Staff Report for Item 3b

Application Number: H15-01-1665

Address: #702 Pearl Street

Partial demolition of side and rear additions with no build back.

DEMOLITION PLAN

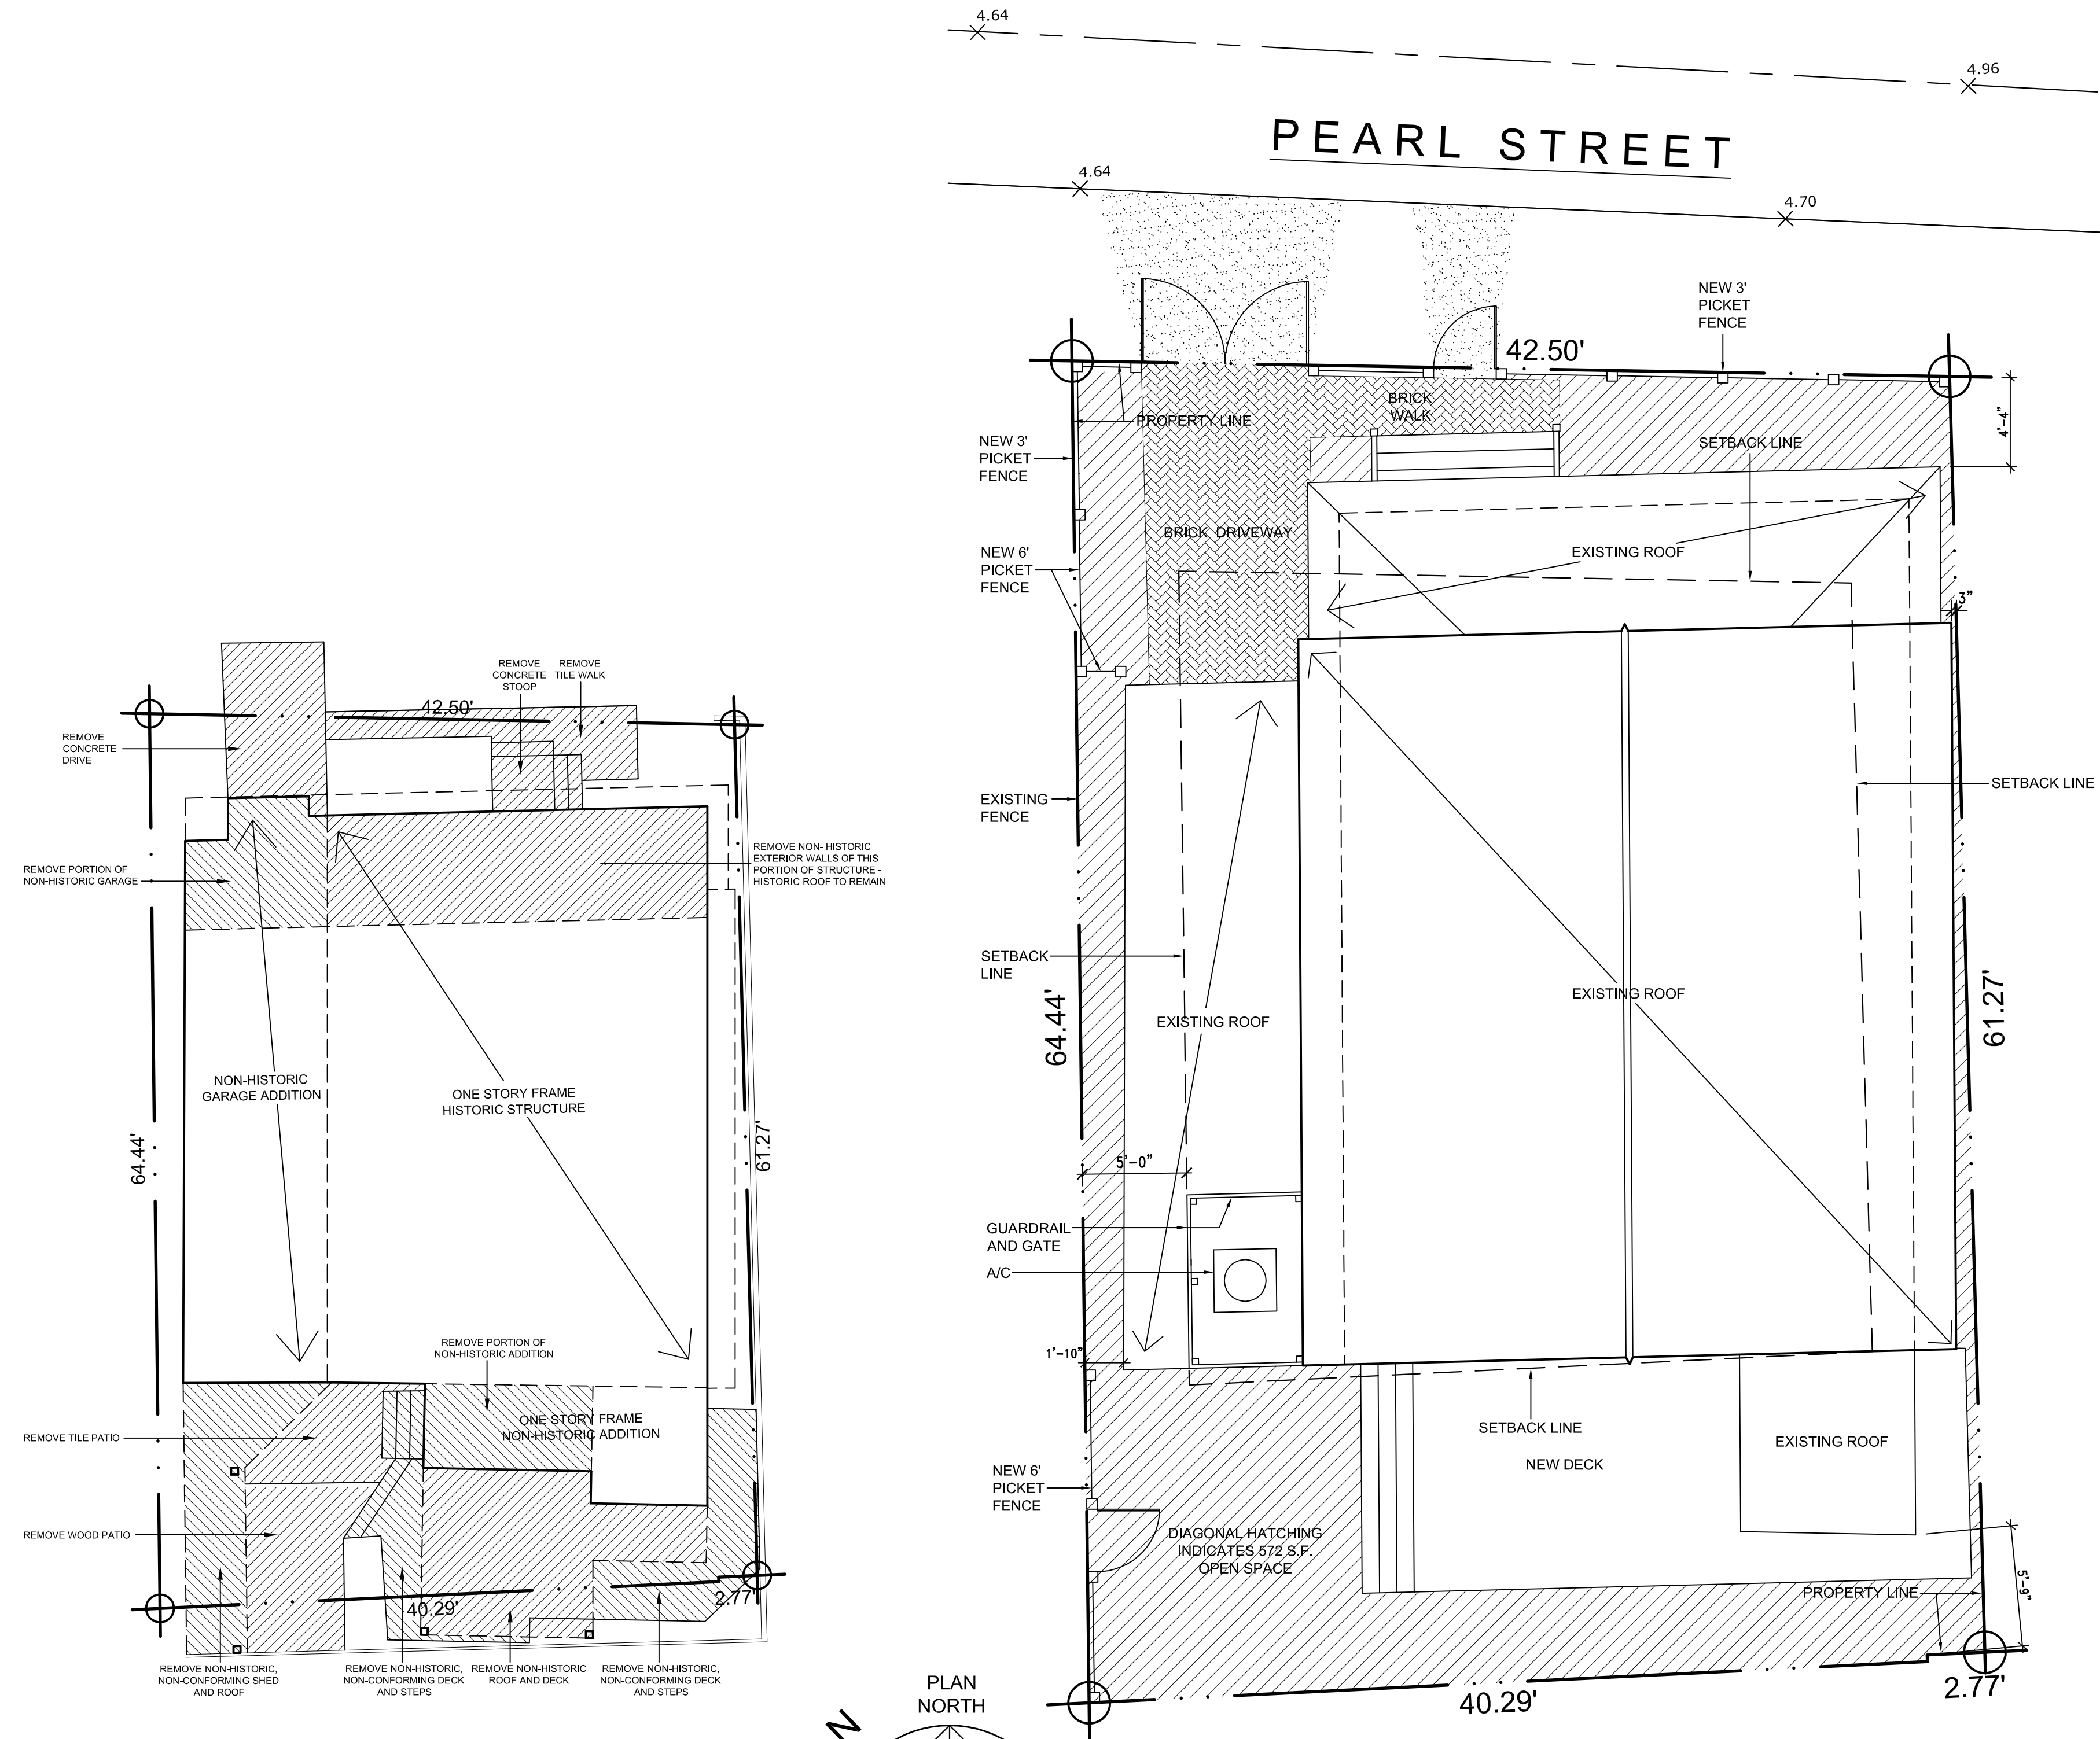
This Certificate of Appropriateness proposes the demolition of a non-historic rear addition and partial demolition of the side garage addition.

- (2) Nor will it destroy the historic relationship between buildings or structures and open.
- (3) This demolition will not affect the front building façade. Instead, the demolition will improve the front building façade.
- (4) Staff does not believe elements that are proposed to be demolished will qualify as contributing as set forth in Sec. 1021-62(3).

ROOF PLAN
PROPOSED PLANS
1/4" = 1' - 0"

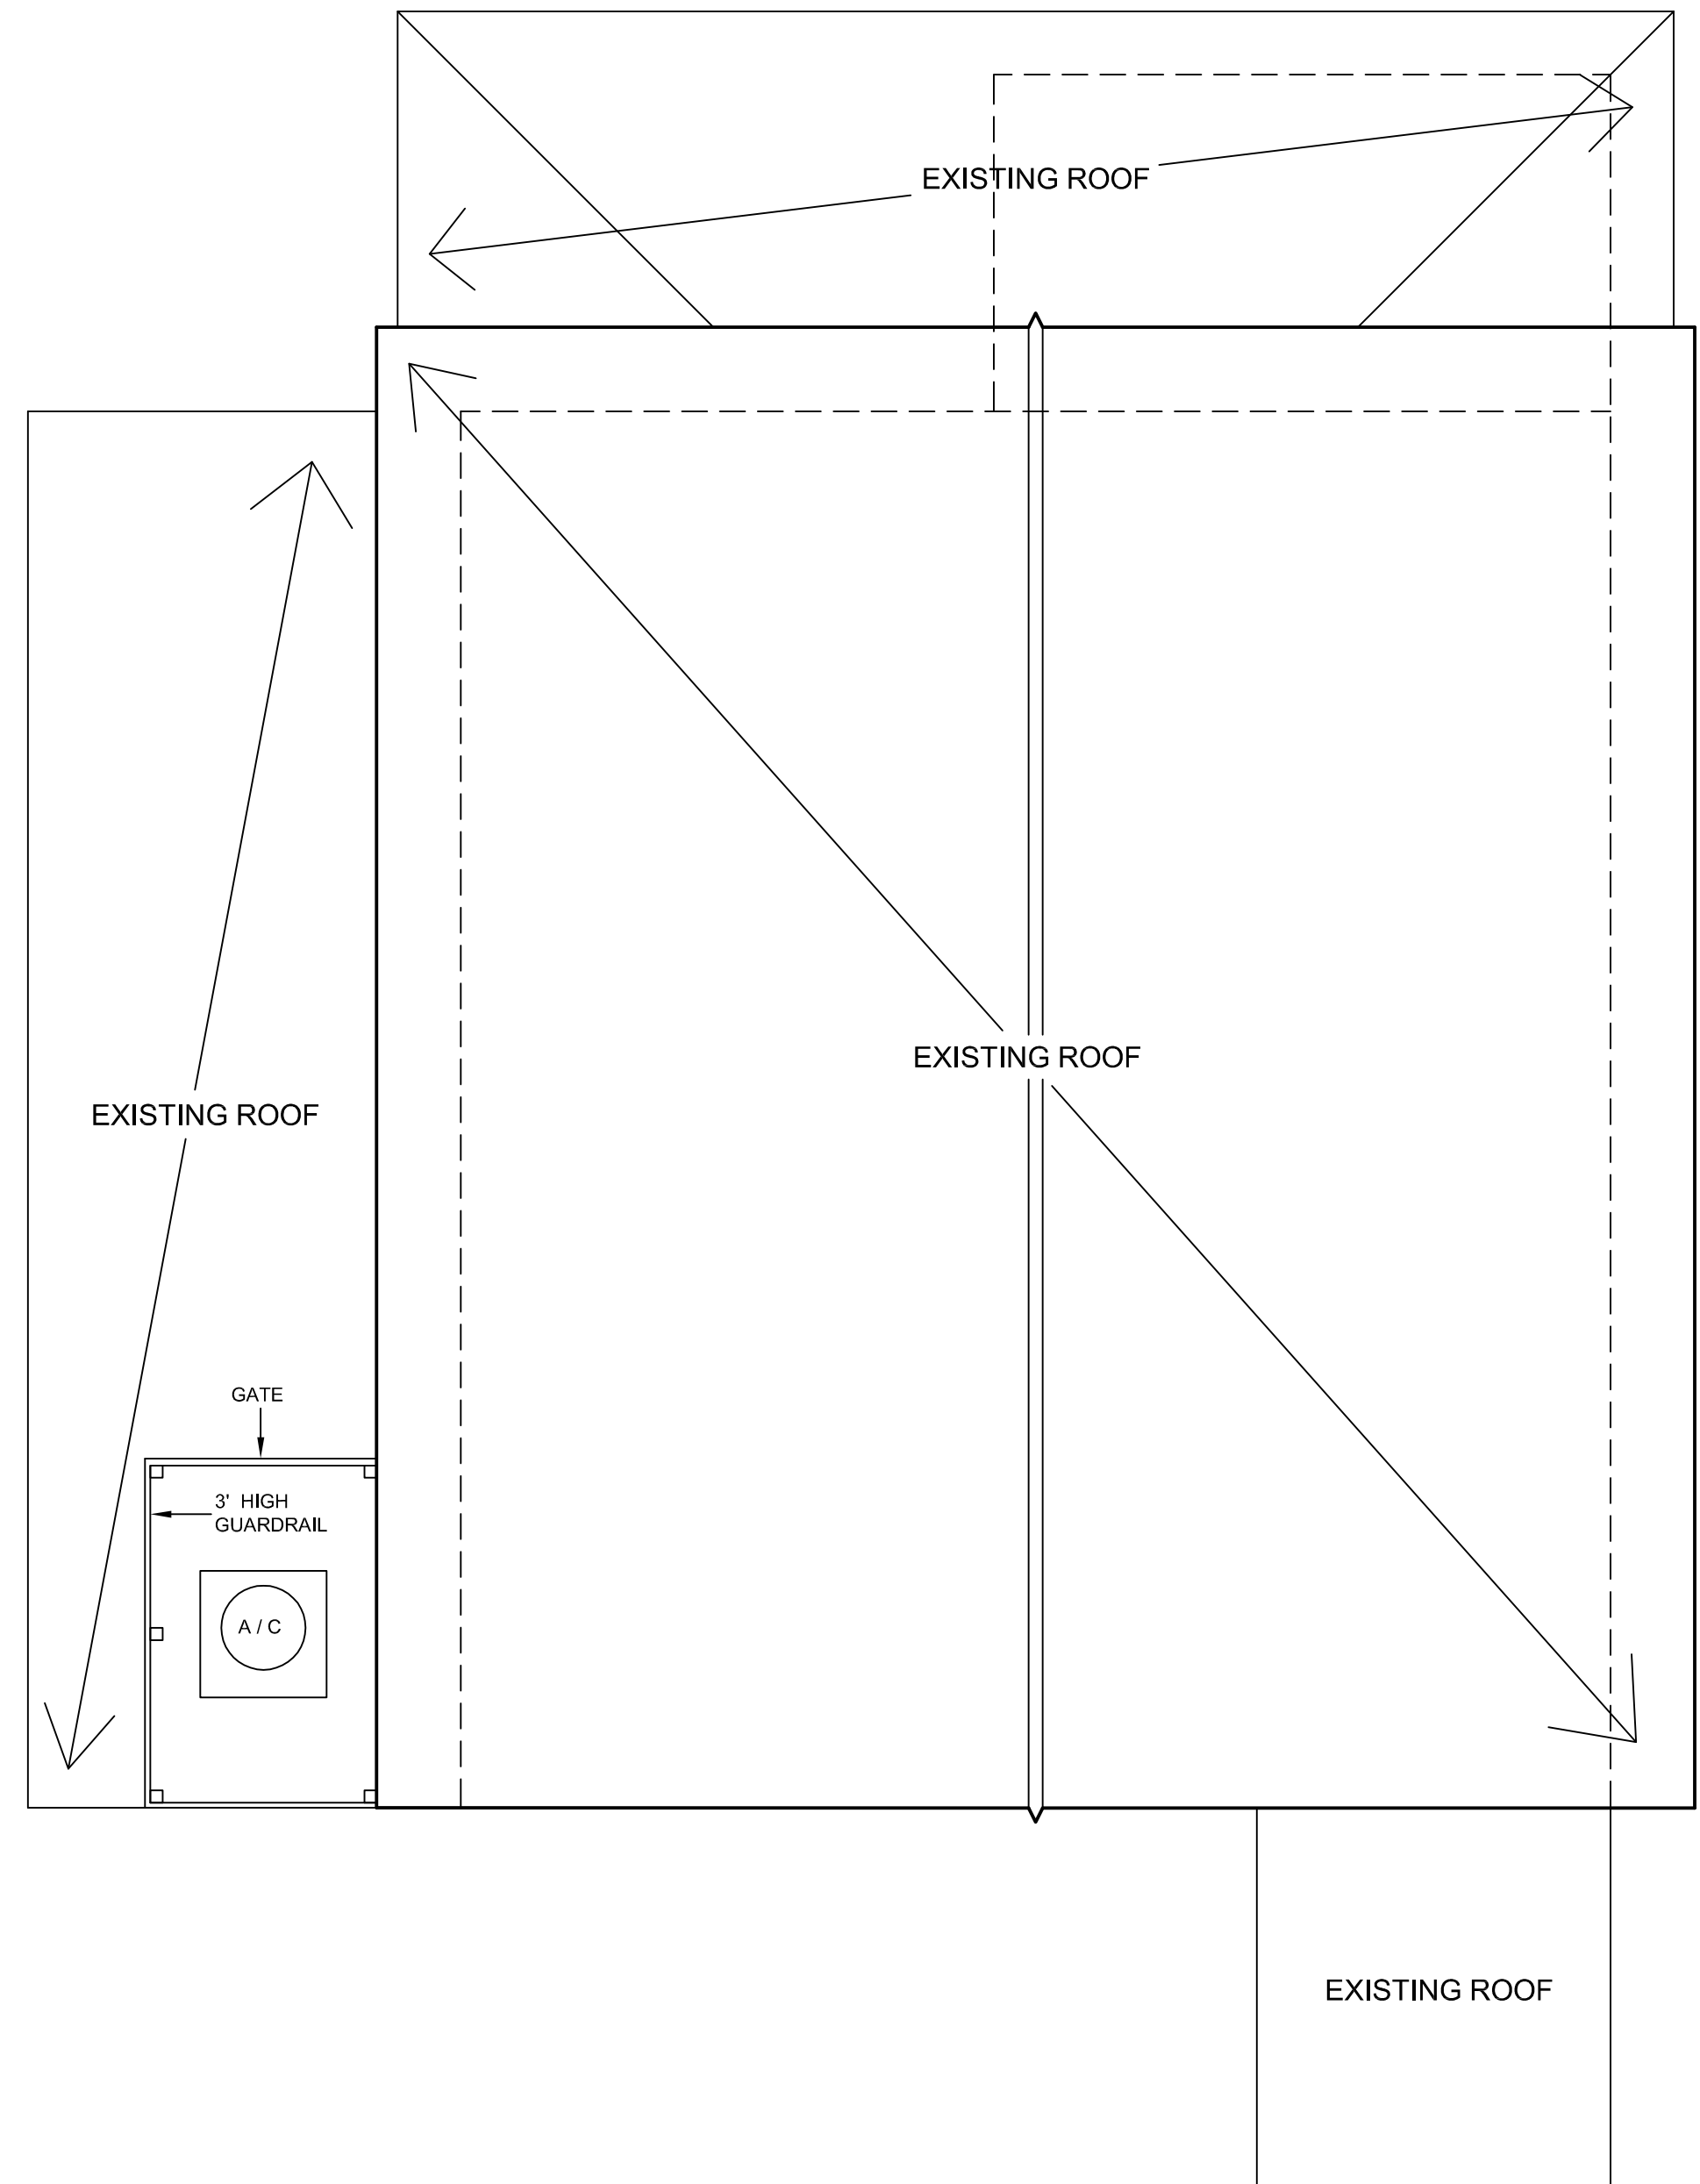
When speaking with Kelly recently about your issue concerning the condenser location, I told her that I would speak with the owner about the matter. I have spoken with them and we thoroughly discussed all the options we were able to conceive of regarding alternate locations of this equipment to the current location on the rear of the garage roof as shown in my drawings.

Because the lot is substandard, the building drastically crowds the rear property line and leaves very little area for outdoor activities and foliage. That and the condition by Planning that such equipment cannot be any closer to the side and rear property lines than 5'-0" leaves no real desirable alternative. I would ask you to look closely at the drawings to verify these conditions.

Furthermore, I am convinced that the proposed location on the garage roof, well outside the side yard building setback line and at the extreme rear of garage would render the equipment not viewable from the street. A visit to the site would verify this. The height at the lowest end of the roof is 9'-6" and it slopes to higher at the house.

As mentioned in the staff report given the 5 foot setback requirement for AC units it is clear that an alternative location on the ground could be considered. If the re-design moves the railings out of the setback and the proposed second story is not in the required side yard setback, planning staff has no issues. Please coordinate with HARC staff moving forward.
